ADDENDUM NO. 1

Project: USCA Pedestrian Bridge
Project Number: H29-9545-PG

This document comprises Addendum No. 1, and forms a part of the Contract Documents and modifies the original bidding documents as noted herein. Acknowledgement of the receipt of this Addendum in the space indicated on the Proposal Form is required. Failure to do so may subject Bidder to disqualification.

4 -Railing and Fencing Elevations

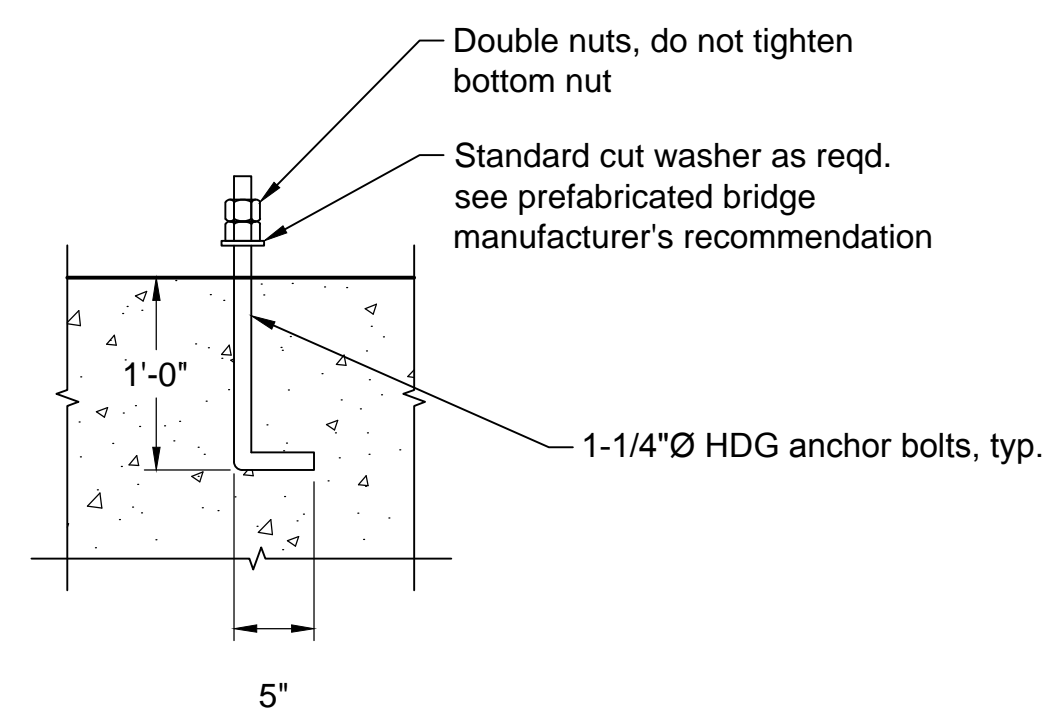
- 1) The drawings reference a ½" 9 gage vinyl-coated minimesh fence but then state openings no larger than 2". Can you please confirm which maximum opening size is correct (1/2" or 2")?

Answer: Per A1.0 the cage is to be 1" 11 gauge vinyl coated. Disregard the reference to ½" 9 gage fence located on sheet S4.0.
